## CITY OF ALLENTOWN HISTORIC ARCHITECTURAL REVIEW BOARD FINAL REVIEW SHEET

Case #HDC-2018-00014 - Proposal to rehab/restore the facade

Property located at: 618 N 6<sup>th</sup> Street

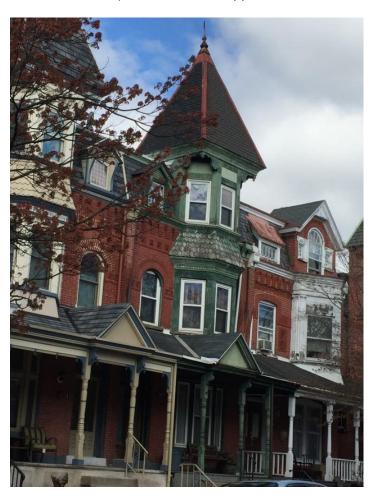
**Evaluation, effect on historic district, recommendations**: The proposed restoration work is historically appropriate with some notes on direction:

- As much funding as possible should be directed towards window restoration and replacement where needed (especially the arched window). New windows should be wood, aluminum-clad wood, or appropriate fiberglass or composite per Design Guidelines. Any original wood windows should be scraped and painted. New storm windows should be considered for energy efficiency where needed but a color other than white recommended.

- Wood balustrades would be appropriate for the porch, and may be necessary for code/safety. Heavy square balusters might be historically appropriate if at least 2" square, although turned would be more historically appropriate.

- Specification for porch light should be submitted for staff approval if replaced.
- Slate and cedar shingle replacements, as well as any re-pointing, should be done
  carefully to blend appropriately with existing. Brickwork appears to be in good condition,
  and with such a fine mortar line, re-pointing should be limited and must follow
  Preservation Brief #2.

**Discussion:** The home owner brought pieces of the historic porch ornament that he found on site and proudly showed to the HARB. Reinstallation of these elements was applauded. The HARB said that the replacement of the arched window on the second floor was a high priority and urged the applicants to do this instead of installing a front porch railing. Mr. Lewnes said the other windows on the façade had been replaced and there was not enough money to replace them with more appropriate windows. They would be painted to blend with a new paint scheme to be provided by Ms. Rabinsky. Other discussion focused on miscellaneous details of the proposed work.

- 1. The proposal to rehab/restore the facade at 618 N 6th Street was presented by Peter Lewnes.
- 2. Any aluminum capping and siding still existing will be removed.

- 3. Original porch trim discovered on site will be reinstalled and painted
- 4. All woodwork, including front porch, will be repaired or replaced in kind, as necessary, and painted

- 5. Arched window sashes will be reinstalled in the existing arched window on the second floor if budget allows. This is a high priority and should be done if at all possible.

- 6. Other replacement windows will be painted. If the dormer multi-light window is original it will be retained and painted.
- 7. A new dusk to dawn porch light (if needed) will be installed after approval by staff.

- 8. Metal caps and finial on tower roof will be painted, and all slate will be inspected, repaired and replaced with like slate if necessary
- 9. Any cedar shingles that need replacing will be replaced in-kind and painted. The proposal to recommend a COA was unanimously approved. (5-0; motion carried; Huber, Jackson, Renaut, Sell, Fillman)
